## UNITED STATES NUCLEAR REGULATORY COMMISSION OFFICE OF NUCLEAR REACTOR REGULATION WASHINGTON, D.C. 20555

August 20, 1992

NRC INFORMATION NOTICE 92-61: LOSS OF HIGH HEAD SAFETY INJECTION

SHEARON HARRIS HIGH HEAD SAFETY INJECTION SYSTEM

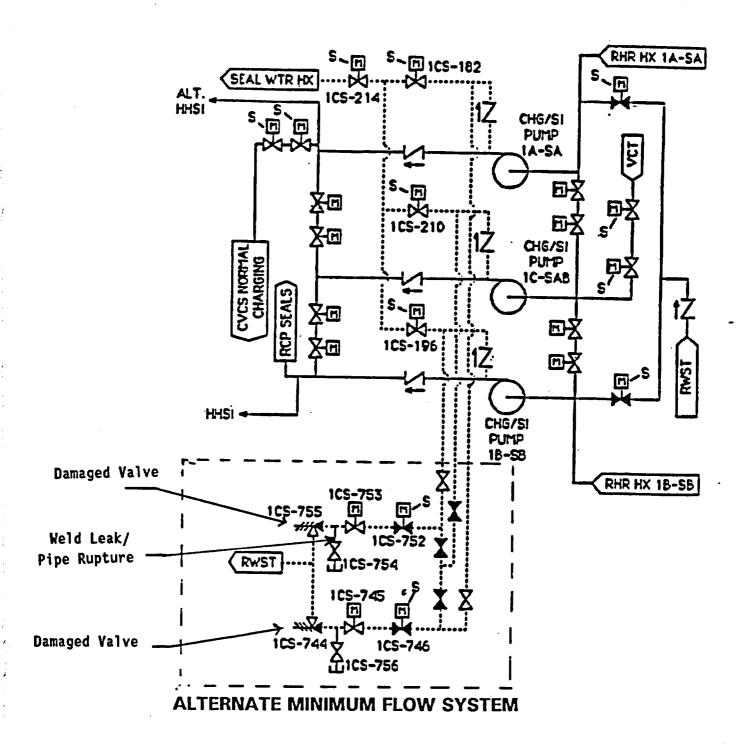
The physical layout of the AMF system piping at the Shearon Harris Nuclear Power Plant results in air being trapped upstream and downstream of the relief valves when they are removed and reinstalled in the system. The upstream isolation valves 1CS-746 and 1CS-752 remain closed until an SI signal is received. This prevents water from refilling this piping. Also, piping upstream of the relief valves does not have high point vents to remove the trapped air.

The AMF system design weaknesses identified at Shearon Harris were:

- 1) The potential for water hammer events upstream and downstream of the relief valves had not been analyzed.
- 2) The AMF system piping had not been analyzed for transient or water hammer loads.
- 3) The potential for relief valve chatter and setpoint drift had not been analyzed.

The licensee has taken corrective actions by revising plant procedures to require the piping upstream of the relief valves to be refilled prior to installation of the relief valves and vented through the relief valves by hydraulic pressure to eliminate the air. The licensee has also repaired the damage identified above. The licensee reported this event to the NRC in LER 050-400/91-008-01 in May of 1991. The licensee is currently evaluating the potential for water hammer downstream of the relief valves.
